**SUNDRY NOTICES AND REPORTS ON WELLS**  
*Do not use this form for proposals to drill or to re-enter an abandoned well. Use Form 3160-3 (APD) for such proposals.*

8. Well Name and No.  
Lonesome Dove 25 Fed Com 1

9. API Well No.  
30-015-31698

**Lonesome Dove 25 Fed Com 1  
30-015-31698  
Rubicon Oil & Gas, LLC  
July 19, 2013  
Conditions of Approval**

Lonesome Dove 25 Fed 1  
Eddy County, New Mexico  
Completed Wellbore  
30-015-31698

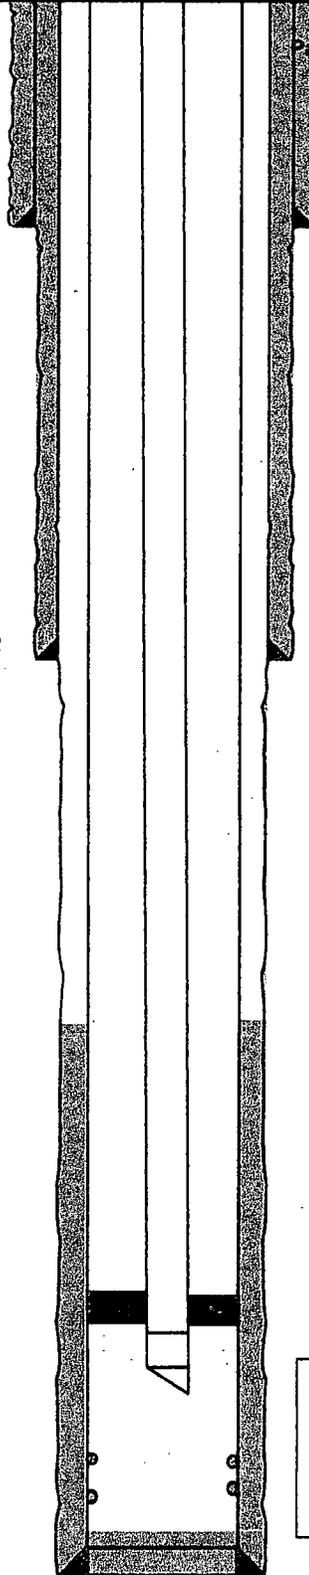
Current production from existing Morrow perforations 10,434-10,710' sub economic and well not able to unload associated fluid. Swab test 2/2013 indicated probable casing leak. ~~Rubicon plans to recomplete well in Yucca formation 4100 to 5200' upon successful plug back of well.~~ *cement remediation only*  
Plan to pull existing tubing and packer, isolate existing Morrow perforations with 5-1/2" CIBP set @ 10,300'. Run casing inspection logs and Isolate potential casing leak with packer / retrievable plug to determine integrity, develop plug back plan with BLM approval to 5500'. Start date of initial work next 45 days.

- 1. The operator shall place CIBP at 10,633' and place a 206' class H cement plug on top.**
- 2. Notify BLM when hole in casing found.**
- 3. Operator to submit a plan for cement remediation and/or casing repair to the BLM after well evaluation.**

**APPROVAL TO PLUG BACK THE MORROW FORMATION ONLY.**
